Date: 3<sup>rd</sup> August 2017  
My ref: 17/01634/PREAPP  
Your ref: PRE.047/17  
Please ask for: Rob Fowler  
Email: rfowler@oxford.gov.uk  
Direct Dial: 01865 252104

**Proposal: Request for Pre-Planning application advice by the Environment Agency for the Oxford Flood Alleviation Scheme at land from North of Botley Road to New Hinksey in the parishes of North Hinksey, South Hinksey and Kennington**

#### **17/01634/PREAPP - review Oxford flood alleviation scheme**

### Oxford’s flood alleviation scheme - General Overview Plan

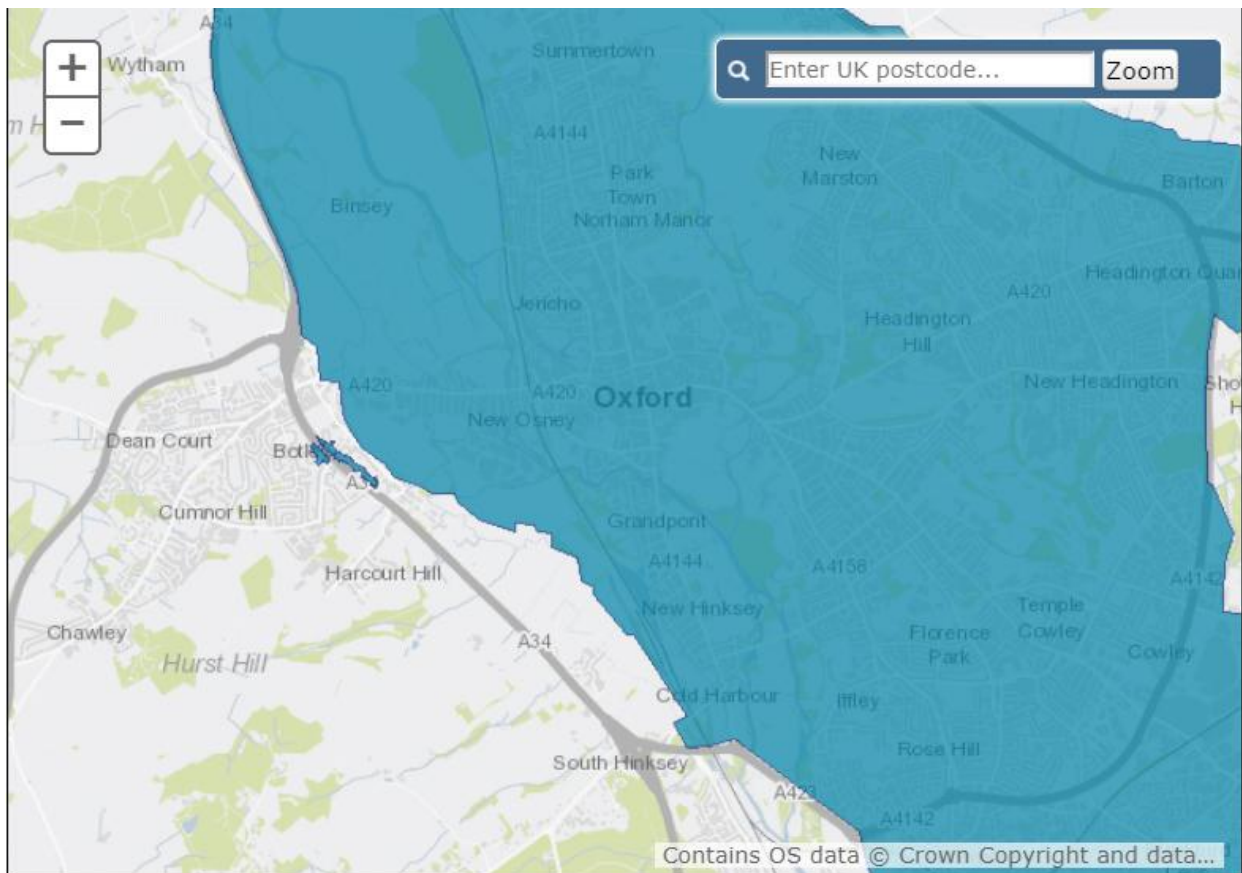
New information of the exact entering and exit points of the Lorries of this scheme has been given upon previous request.

The analysis of the provided plans, have allowed the identification of 6 potentially sensitive areas for Air Quality within the scheme. Those will be described below, together with the appropriate air quality comment.

### **1 – Access and exit for the Works at Osney Mead via Botley Road (Area 3)**

This area is located within OCC's Air Quality Management Area, and it is therefore extremely sensitive from the Air Quality point of view. Is the access going to be made via Ferry Hinksey Road? OCC measures NO<sub>2</sub> in the corner of Botley Road with Hill View Road (60 m) away from Ferry Hinksey Road. The latest Air Quality Monitoring data (2016) indicated an NO<sub>2</sub> annual mean value of 40ugm-3, which is currently the annual mean limit value for NO<sub>2</sub>.

### **2- Main access and exit location for the construction works via A34 Southern bypass road (South Hinksey)**

### **3 – Access to Area 2 in Botley Road for delivery and small vehicles (Seacort stream). Access not for Haulage vehicles)**

### **4 – Access to site (Area 1) Haul route for removal of material via seacourt Park & Ride access**

### **5- Main access and exit for constructing the northern site**

## **6- Access to Area 4 – New Hinksey**

- An air quality assessment will have to be conducted considering in general all the aspects described on my AQ comment 1 above and including in specific all the 6 identified air quality sensitive areas mentioned on my AQ comments 2

- Additional Air Quality monitoring will have to be conducted in 6/7 new locations, as they represent OCC and other LA's air quality blind spots in what are considered to be sensitive areas – places that are not currently being covered by the existing Air Quality monitoring network and that are estimated to suffer from air quality impacts as a result of the implementation of the scheme. The new locations are to be agreed with the LA that has the legal duties to monitor Air Quality in those areas

- It is recommended that a map of Oxford, with the totality of the expected lorry routes could be clearly shown at pre application stage, together with, if possible a list of names of those roads, as well as the exact entry/exit address locations of the scheme pin pointed in the map and listed below, to cross check with the information gathered on this review.
